CITY OF DUBLIN, OH

Planning Report

Deer Run PUD – Deer Run

Agenda Item	3
Case Number	10-062Z/PDP/PP
Site Location	Located on the northeast corner of the intersection of Memorial Drive and Dublin Road.
Proposal	A new Planned Unit Development District for 51 acres currently located within Deer Run Estates subdivision and Wasatch Estates Planned Commerce District. The proposal is for a single-family development, consisting of 9 estate lots, 37 cluster lots and 10 acres of open space.
Applicant	Robert Walter, owner; representative by Michael Close, Wiles, Boyle, Burkholder and Bringardner Co., LPA.
Case Manager	Jennifer M. Rauch, AICP, Planner II (614) 410-4690 jrauch@dublin.oh.us
Requests	Rezoning with Preliminary Development Plan and Preliminary Plat Review and recommendation to City Council under the Planned District provisions of Zoning Code Section and Subdivision Regulations.
Planning Recommendation	Approval of the rezoning with preliminary development plan and preliminary plat with conditions. Based on Planning's analysis, the proposal complies with all applicable review criteria and the existing development standards within the area and approval of all applications is recomm

<p>City of Dublin Land Use and Long Range Planning</p>	<p>10-062Z/PDP Preliminary Development Plan / Rezoning Deer Run Estates Memorial Dr. and Dublin Rd.</p>	 <p>0 1,250 2,500 Feet</p>
--	---	---

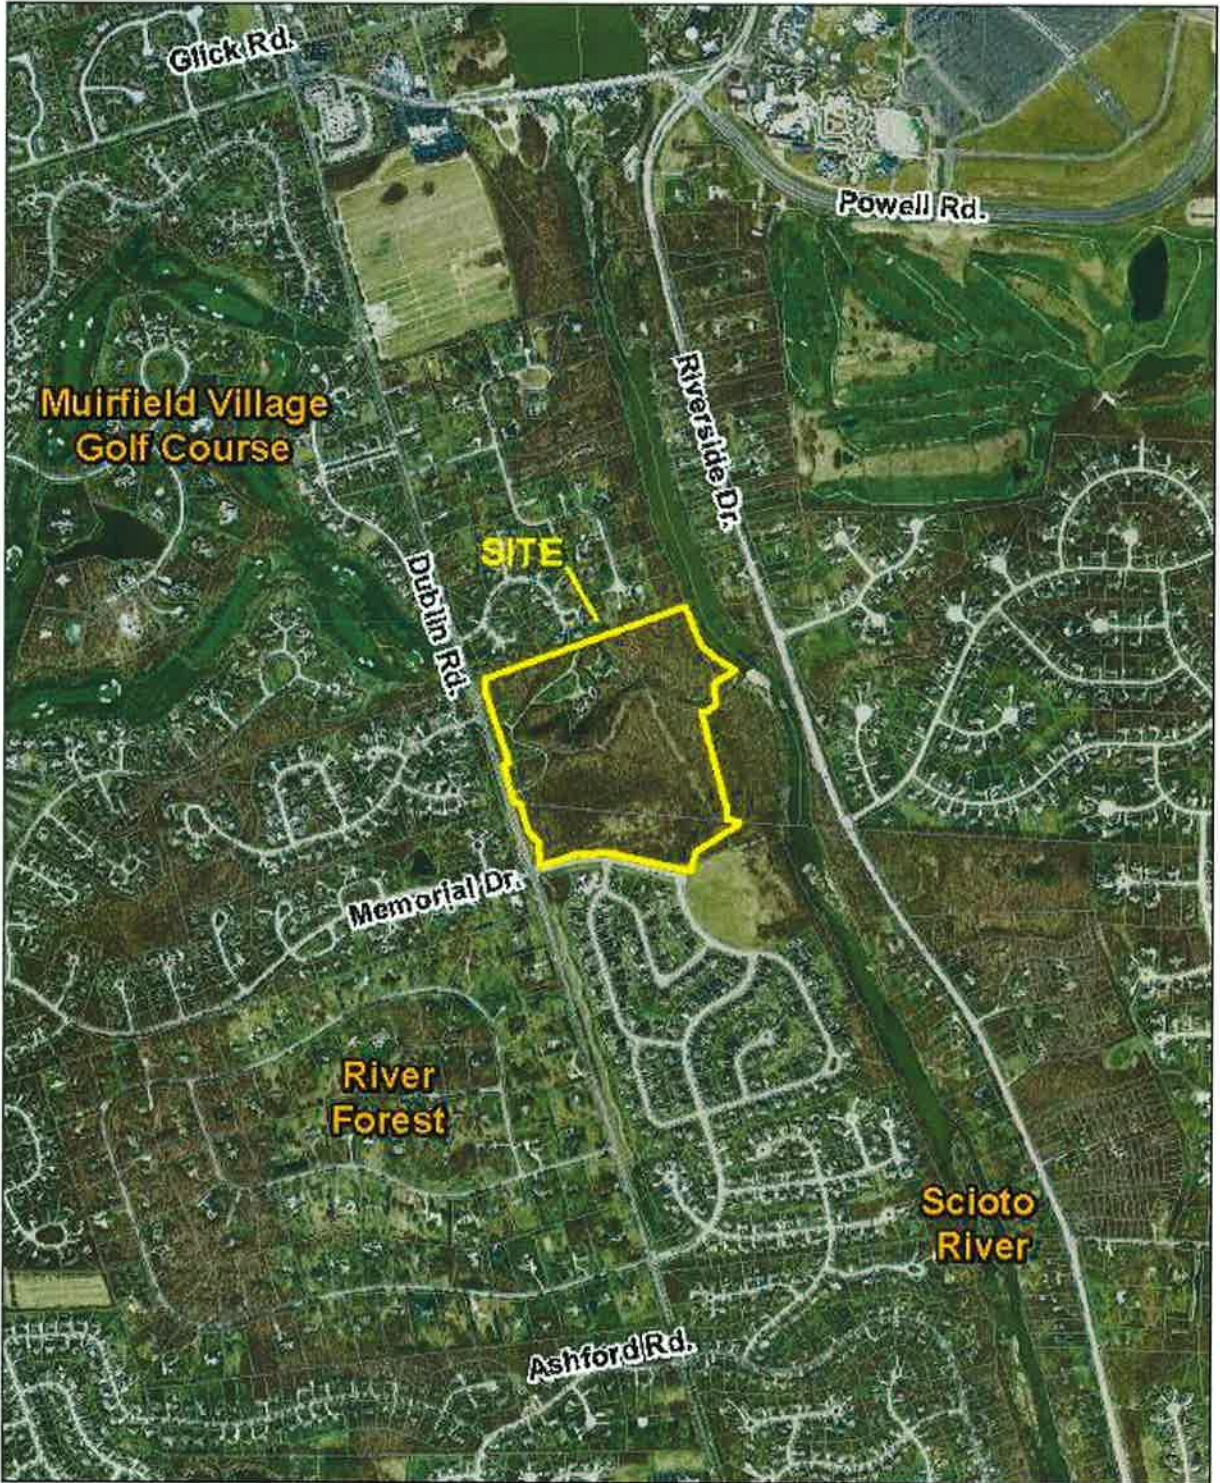
- 1) The plans be revised to relocate the gate and boulevard treatment at the entrance along Memorial Drive farther into the development to provide stacking space for vehicles waiting to enter;
- 2) The text and the plans be revised to incorporate a five-foot sidewalk along the north side of Memorial Drive, and the sidewalk be continued to connect to existing sidewalk stub on the east side of Vista Ridge Drive, subject to Engineering approval;
- 3) The text and plans be revised to incorporate a four-foot sidewalk within the private street easement for Subarea C; and
- 4) The text and plans be revised to extend the four-foot sidewalk between lots 28 and 29 from the proposed development into Amberleigh Park to allow easy access to the extensive park trail system, subject to approval by Engineering and Parks and Open Space.

- 1) The applicant should ensure that any minor technical adjustments to the plat should be made prior to City Council submittal.
